Docket Nos.: 50-440
and 50-441

Subject: Resolution of SER Confirmatory Issue (59) Regarding FSAR Amendment
Changes to Quality Assurance - Perry Nuclear Power Plant (Units 1
and 2)

17.2 Quality Assurance During the Operations Phase

Figure 17.1 Perry Nuclear Power Plant project organization (Revision 1)

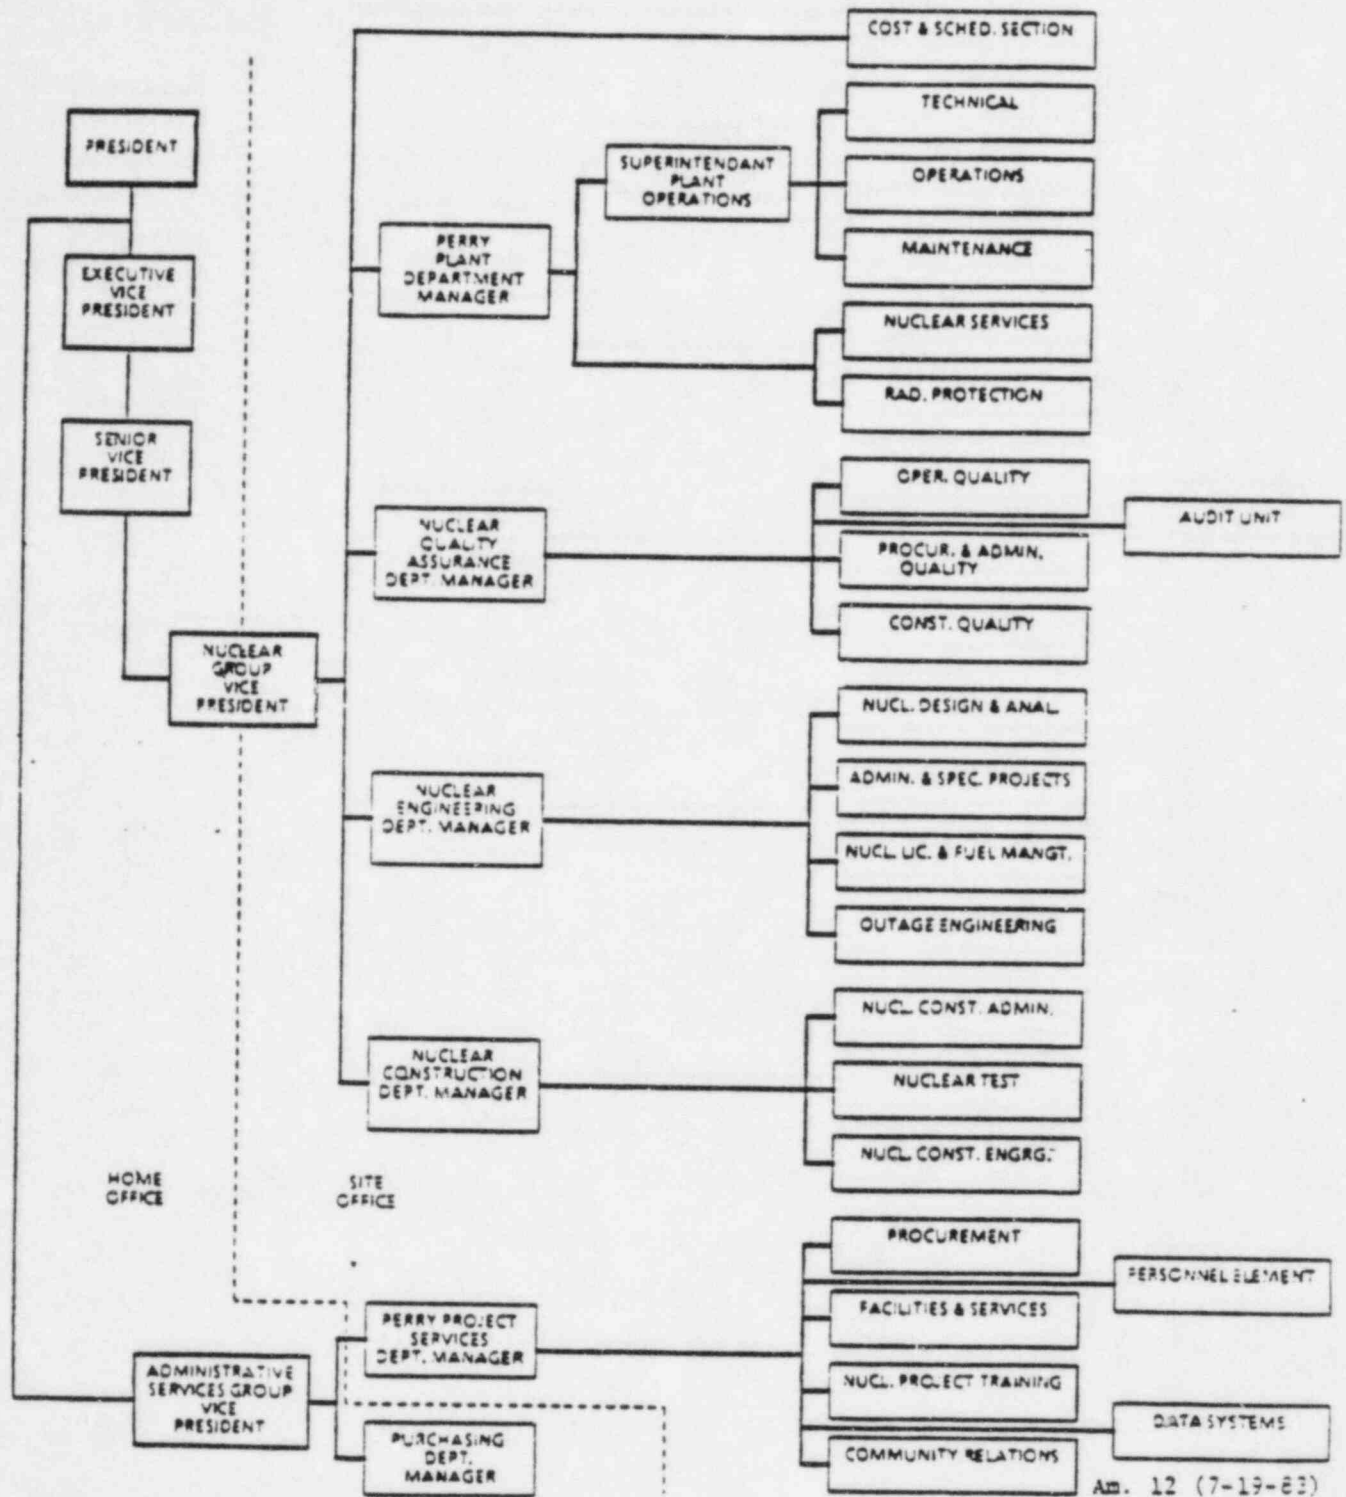
The structure of the organization responsible for the operation of Perry and the establishment and execution of the operations-phase QA program is shown in Figure 17.1.
